Work Order ID 103310

Item Name: LUG

| DESIGN | PH | DART AEROSPACE LTD HAWKESBURY, ONTARIO, CANADA | |

| DRAWING NO. D3394 | | TITLE LUG | | REV. B | DART AEROSPACE LTD ENGINEERING ORDER | | D.E.O. NO. D3394-B-1 | | SHEET NO. SHEET 1 OF 1 | | SCALE NTS |

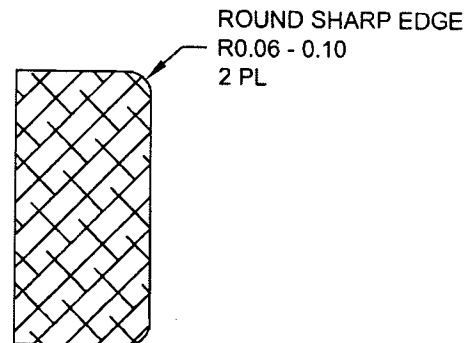
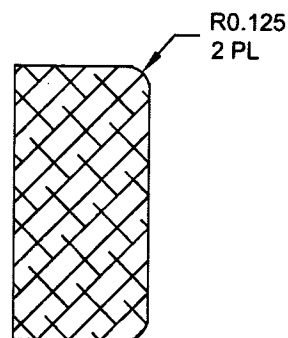
SHEET 4 ZONE A,1 MODIFY SECTION A-A AS SHOWN:

REASON: DRAFTING ERROR

| DRAWING NO. D3394 | TITLE LUG | REV. B | DART AEROSPACE USA, INC ENGINEERING ORDER | | D.E.O. NO. D3394-B-2 | SHEET NO. SHEET 1 OF 1 | SCALE NTS |

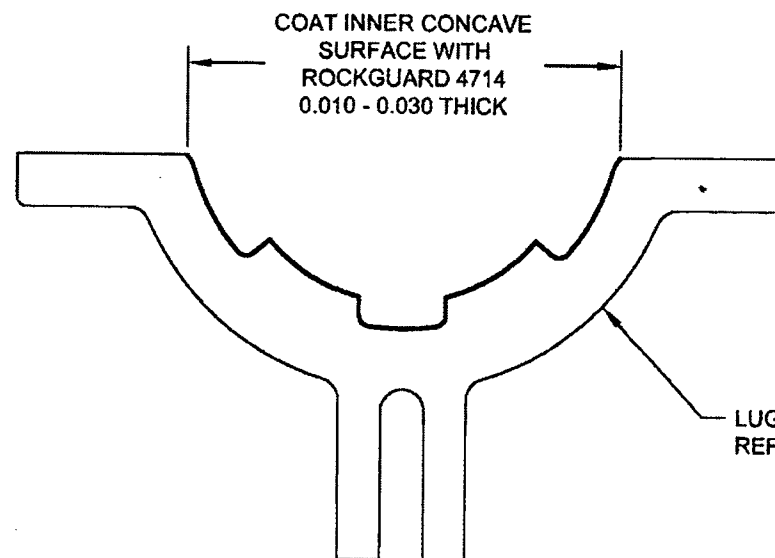
ADD D3394-xRG OPTION

D3394-xRG MOUNTING LUGS ARE INDENTICAL TO D3394-x MOUNTING LUGS, HOWEVER AFTER FINISH, COAT INNER CONCAVE SURFACE WITH "PLUS ONE ROCKGUARD 4714" AS SHOWN BELOW.
